# HWY21-24 at Airport Road Street Name Change

CITY PLANNING COMMISSION

FORMAL MEETING – February 11, 2026

SUBD-25-0132

## SITE PLAN

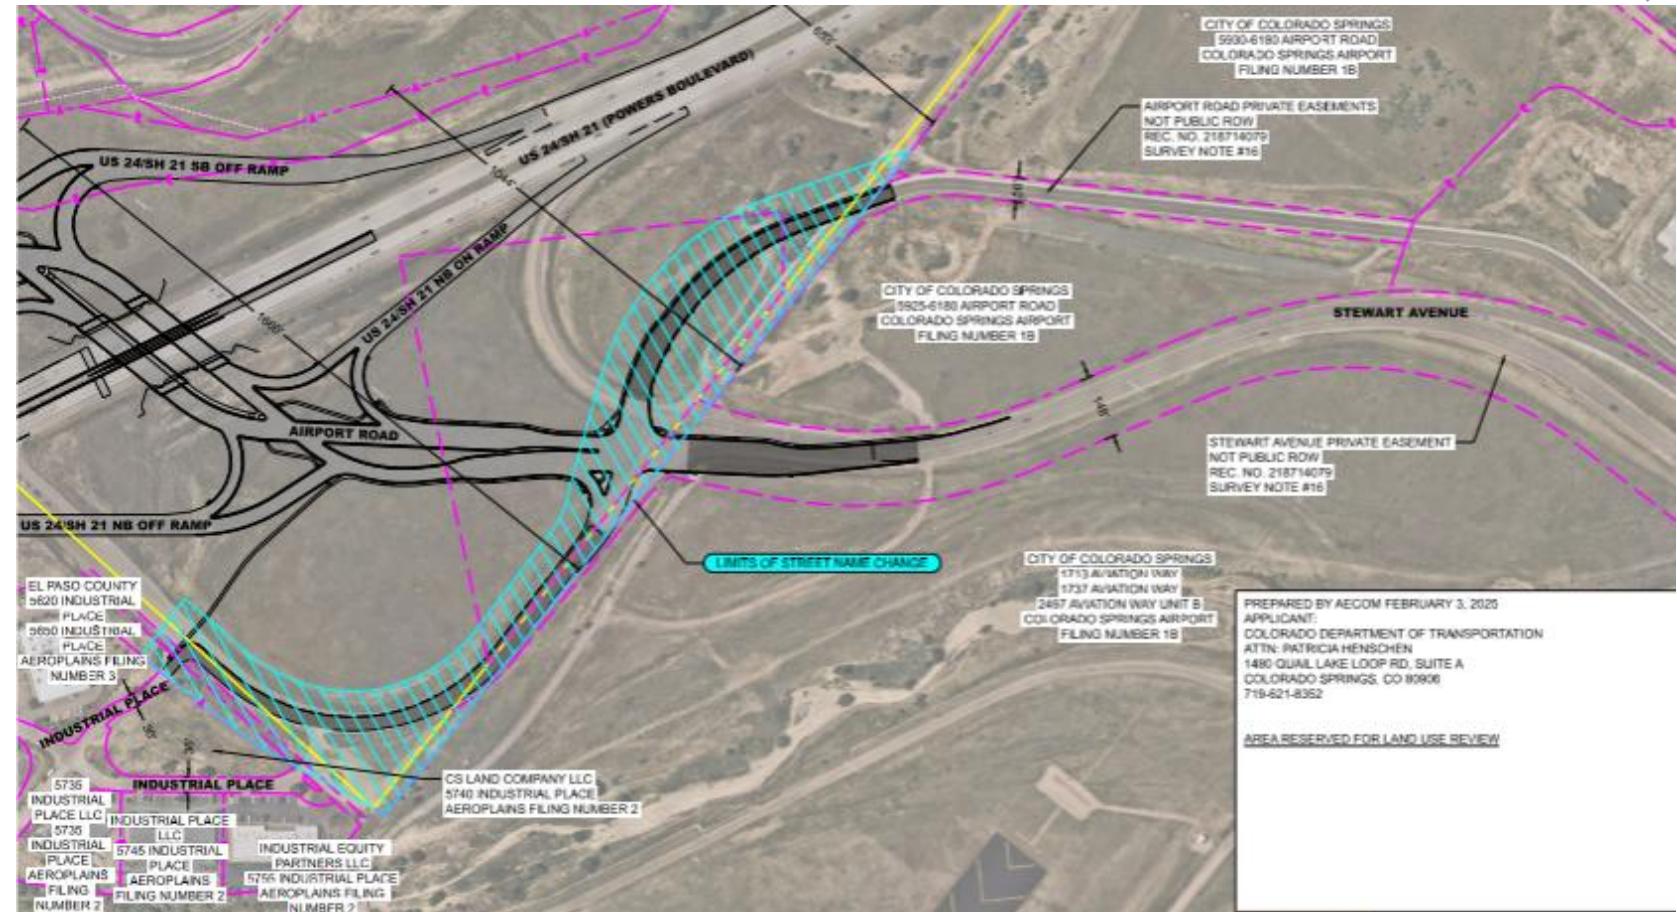
Show the proposed street name and impacted addresses on this plan as Current Addresses and Proposed Addresses.
